DKS MEMORANDUMS

MEMORANDUM

SUBJECT: Villebois Urban Village Master Plan Amendment Transportation Summary
P02246-000-004

TO: Eldon Johansen, City of Wilsonville
FROM: Ransford S. McCourt, P.E.
DATE: April 6, 2004
SUBJECT: Villebois Site Plan Review Comments P/A No. 02246-000

Figure 1
Villebols Urban Village
LEFT TURN LANE NEEDS

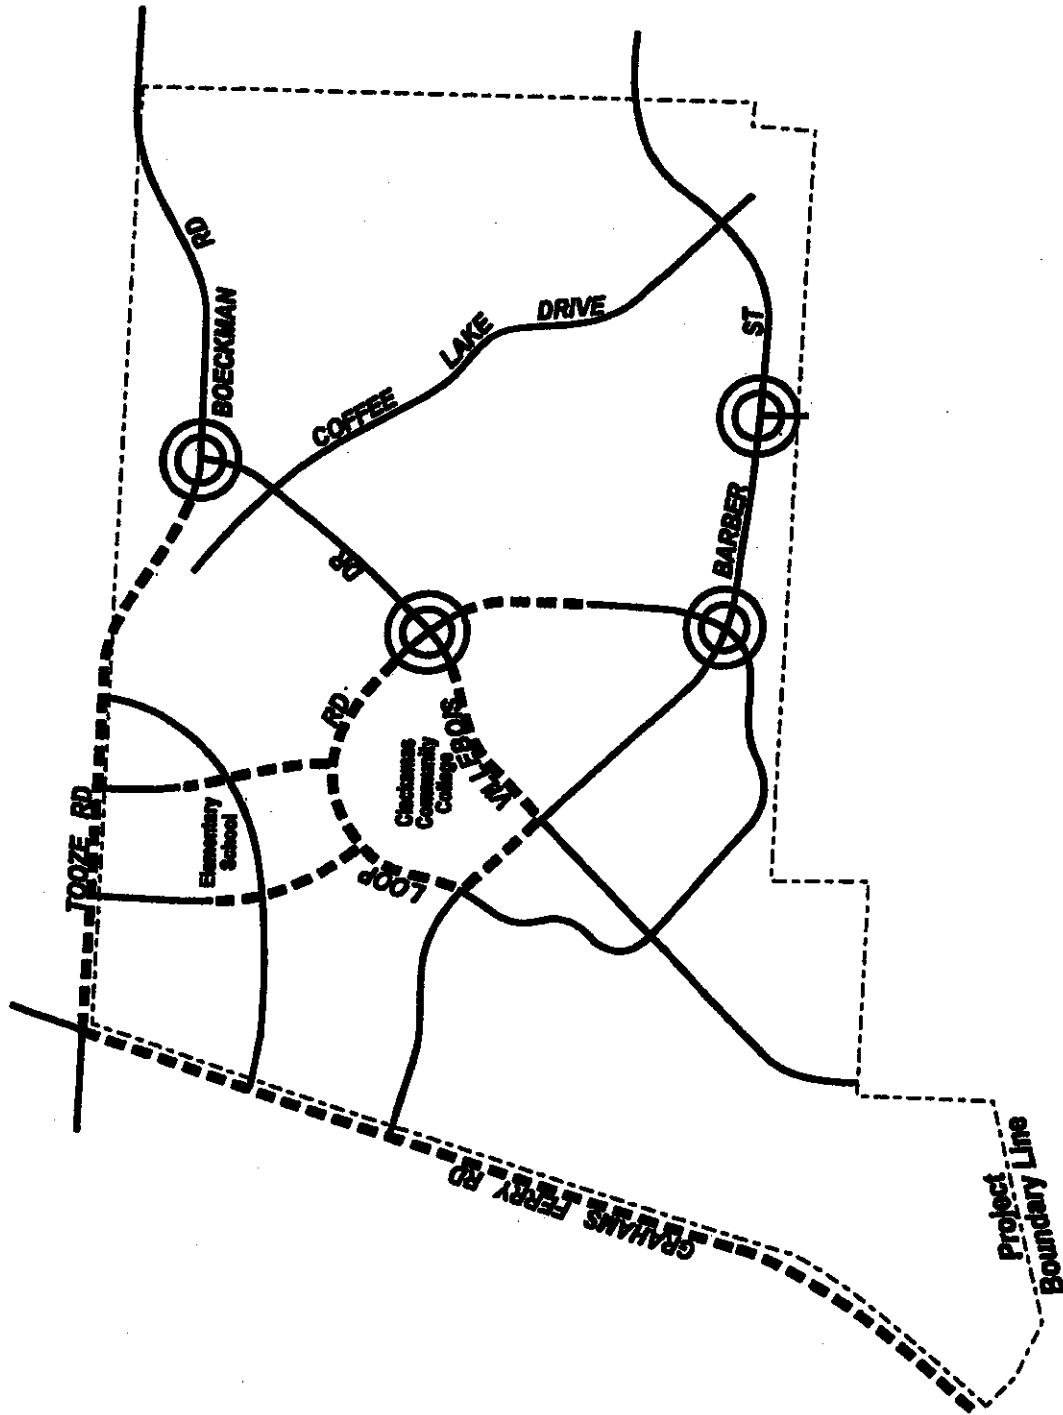
addition of CCC. On Loop Road and Villebois Drive, the volume of traffic would be very near the threshold for left turn lane warrants depending upon the site location of CCC. Additionally, depending upon the bus circulation route for the elementary school and on-site circulation design, turn lanes may be needed approaching and departing the school. More analysis would be needed in this area if CCC does decide to relocate to an expanded Villebois campus. The attached Figure 1 indicates the segments where left turn lanes may be necessary given the current concept location of CCC and the elementary school.

• No Driveways within 200' of Roundabout Edge

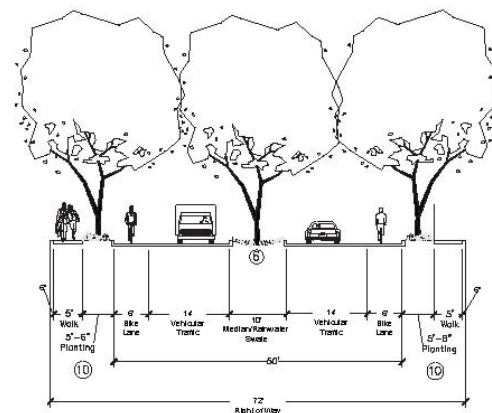
Nature trail connection stubs from SW Grenoble Street and SW San Remo Court were shown on the currently adopted Parks and Open Space Plan (Figure 5) that are located north of the LEC property. The applicant shows these nature trail connections in their revised Figure 5 dated July 26, 2013. This revised plan also shows east and south connections from the internal Villebois nature trail to the Coyote Way Trail that is adjacent to the LEC property which is appropriate. We recommend one additional connection of the Villebois nature trail to the sidewalk on SW Normandy Lane. This additional connection is shown in the Appendix.

Recommendation: *Figure 5 should be updated to show the planned nature trail connectivity as identified by the applicant with the addition of a trail connection to SW Normandy Lane. Add a third paragraph to the Continuity of Streets and Trails subsection in Chapter 5 as follows:*

Provide nature trail connections between the LEC property and SW San Remo Court, SW Grenoble Street, and Normandy Lane. Also provide east and south trail connections from the LEC property to the Coyote Way Trail within Grahams Oak Nature Park.
